## Application for Works Approval

**Works Approval Number** W6834/2023/1

**Applicant** Vango Mining Limited

**Premises** Marymia Gold Project  
Mining Tenements M52/217 and M52/218  
MEEKATHARRA WA 6642

Figure 2: Proposed Trident underground borefield, dewatering pipeline, ROM Pad and stockpile areas

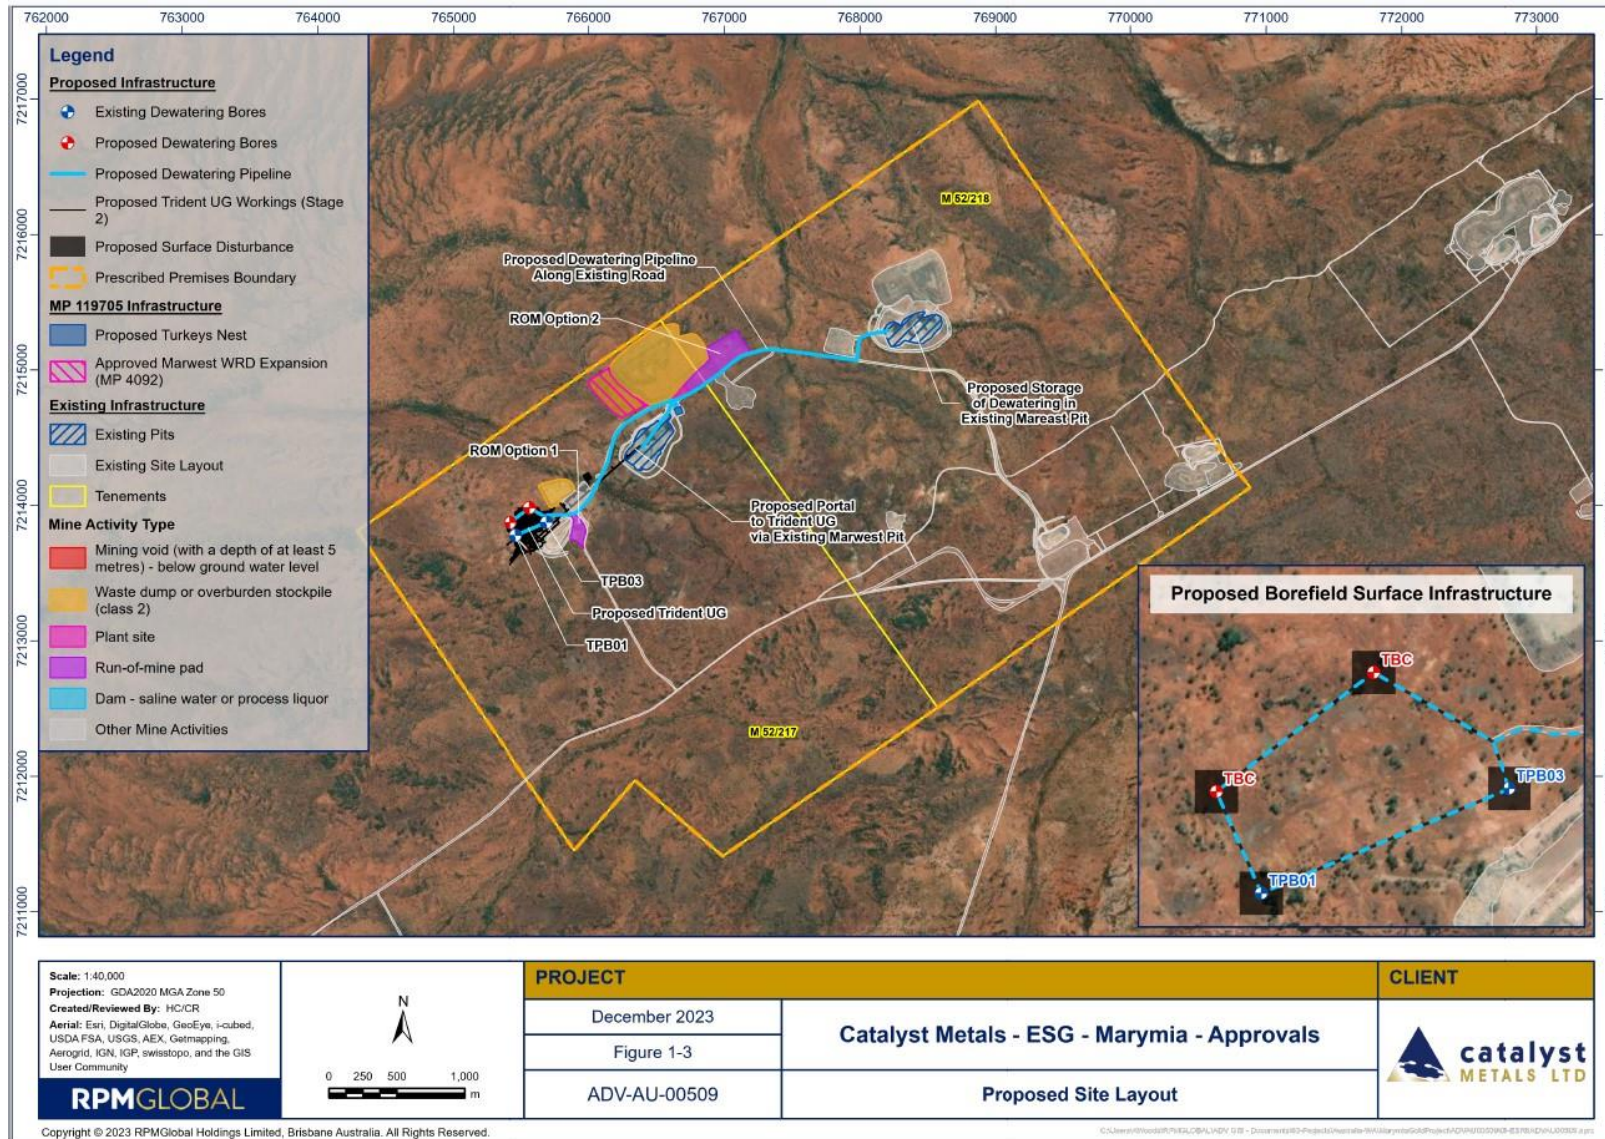
<p>Works Approval</p>		
<p>Table 1 – Item 1 - In Pit sumps - Provide information including proposed configuration/dimensions.</p> <p>As per Schedule 1 Figure 2.</p>	<p>Marwest pit will be dewatered on a campaign/as required basis to ensure water levels are managed within this void, and therefore avoiding any safety or flooding concerns regarding access to the Trident portal.</p> <p>It is expected that a standing water level of 2.5-5 vertical metres will be maintained as a standard in the lower level of the pit to minimise mechanical risks associated with pumping slurry water. In cases where water levels surpass this range, the permanent pump infrastructure at the lake edge will be activated. The pump infrastructure will be permanently located along a section of the existing pit ramp where safe access is feasible and where suction lines/submersible pumps have sufficient water depth without 'bottoming</p>	<p>In-Pit sump removed from Table 1. Pit-lake dewatering infrastructure requirements included in Table 1.</p> <p>Consequently, dewatering of the Pit-lake has been redescribed in section 2.2.1 of the Decision Report.</p>
